# Authorized Field Change

**AFC G-03902**

**Subject File:** FRONT END SHEET METAL

**Subject:** The Hood Dampening Cylinder, which Restrains the Hood during Opening and Closing, may Separate or Pull from the Hood Mounting Surface on 9900i and 9900ix Models Built Between April 19, 2001 and January 2, 2002

**Figure 2 Scuff, Clean and Prep Hood Surface**

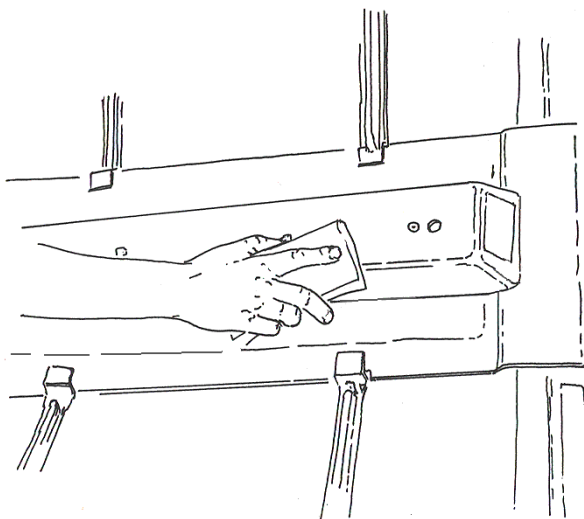
6. Remove hood dampening cylinder bracket.
7. Scuff, clean and prep hood surface for adhesive (Figure 2).

**Figure 3 Trial Fit New “C” Channel Reinforcement and Cylinder Bracket**

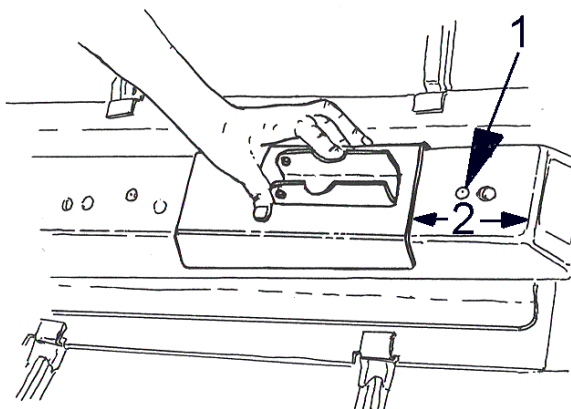
**NOTE – The “C” channel reinforcement plate is not symmetrical. When properly located, the dampening cylinder bracket mounting bolts will align with the original mounting holes.**

8. Trial fit the new “C” channel reinforcement, Part Number 3577407C1, and the dampening cylinder bracket and mark location (Figure 3).

1. Arrow indicates hole which will not be covered when the “C” channel reinforcement plate is properly located.
  2. Position “C” channel 4.61 inches from edge as shown.
9. Scuff and clean the inside of the “C” channel reinforcement plate and evenly apply Fusor T20/T21 adhesive.
  10. Install the “C” channel reinforcement to the previously marked area.
  11. Reinstall the dampening cylinder bracket to the “C” channel reinforcement . Install the bolts and tighten to 15 Lbf-ft (20 Nm).
